Product Change Notification

ECNS26-005
August 26, 2026
EM Devices Corporation

Change used materials of signal relay.
Relay Type: EA2, EB2, EC2, EE2 Series

1. Operate & release voltages

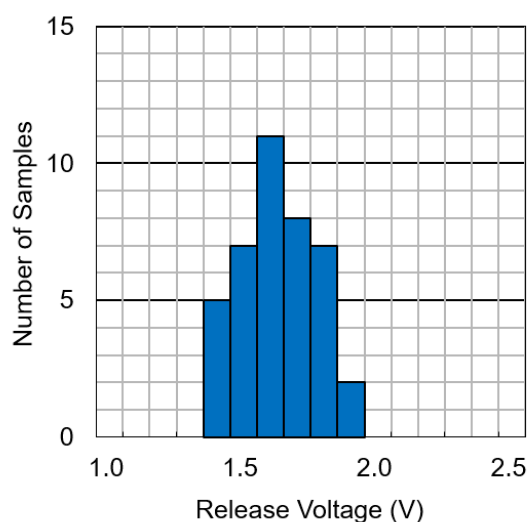
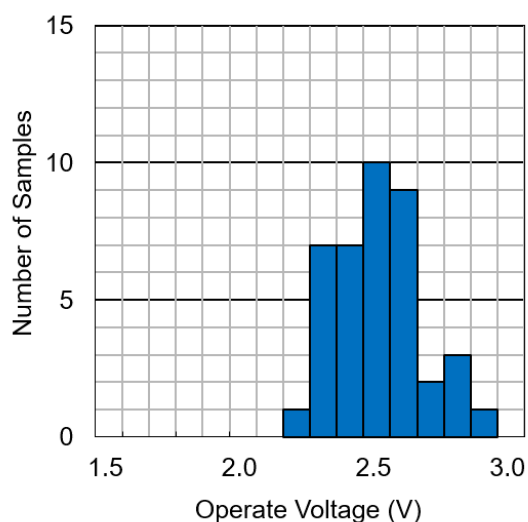
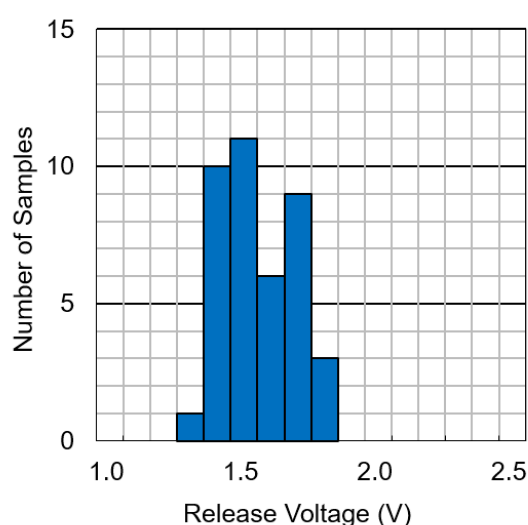
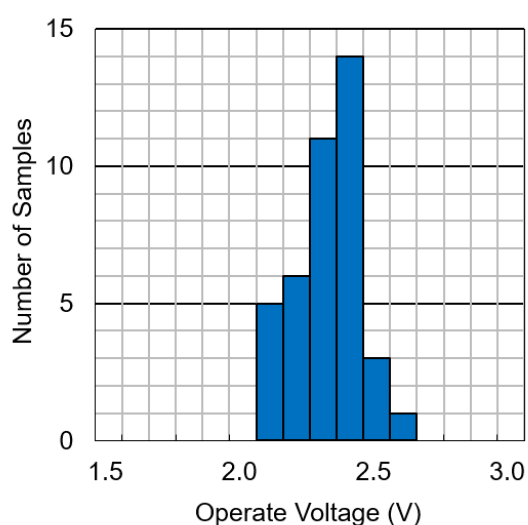
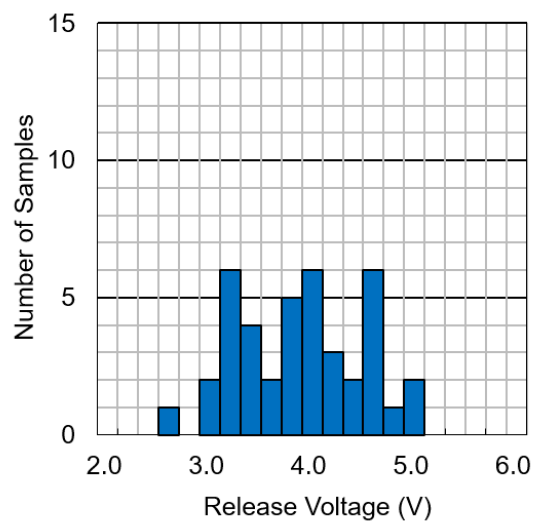
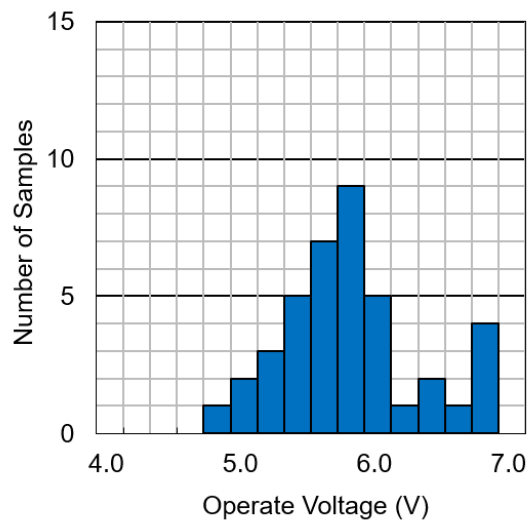
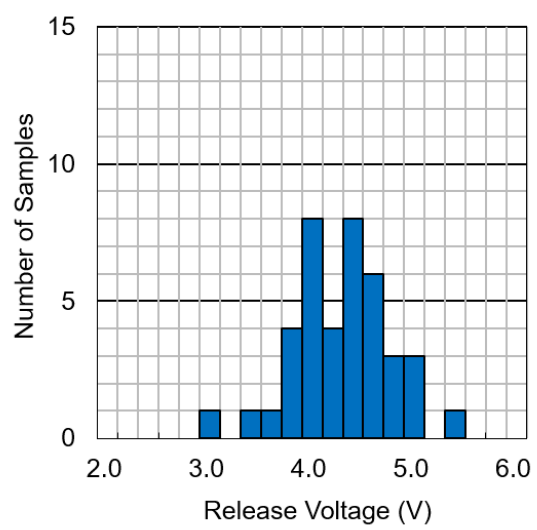
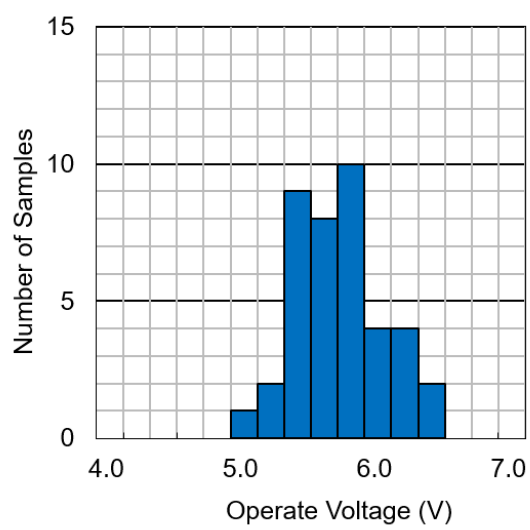
Change of magnet

Item	Current	New
Material	Sm-Co magnet	Fe-Cr-Co magnet
Manufacture	A Company	B Company
Delivery Status	Magnetized products	Non-magnetized products

Note: This change does not change product specifications such as external dimensions and performance. Names of materials and manufacturers are not disclosed. Due to a change in the delivery status, a new magnetization process using a new magnetization device will be added after the magnet assembly stage in the manufacturing process.
